# Surveillance Report 1/24/19

## Pipeline Compliance Surveillance Initiative (CSI)

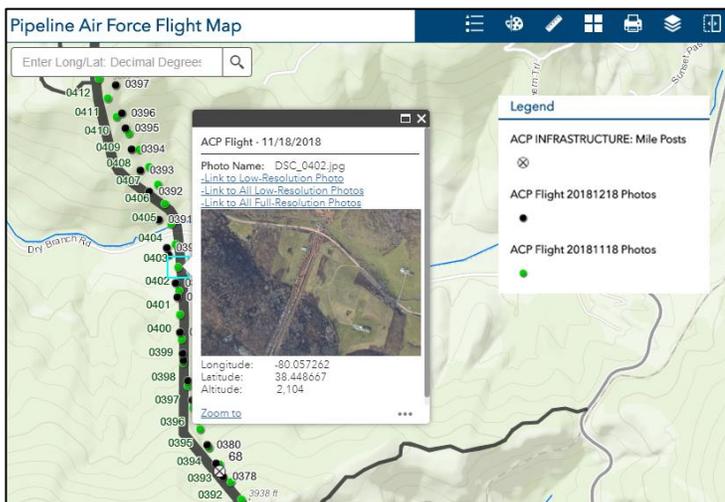
ACP STREAM CROSSING IN POCAHONTAS COUNTY. THE CROSSING DOES NOT CONFORM TO THE METHOD SPECIFIED IN APPROVED PLANS.

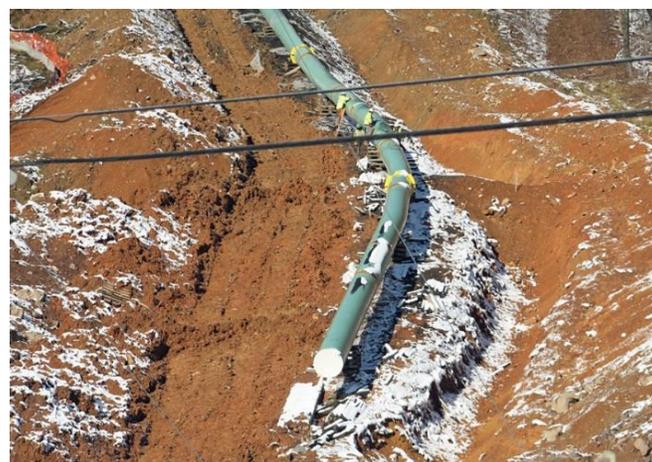
ACP CONSTRUCTION IN POCAHONTAS COUNTY. WATER BARS ARE NOT INSTALLED AS REQUIRED FOR STEEP SLOPE CONSTRUCTION.
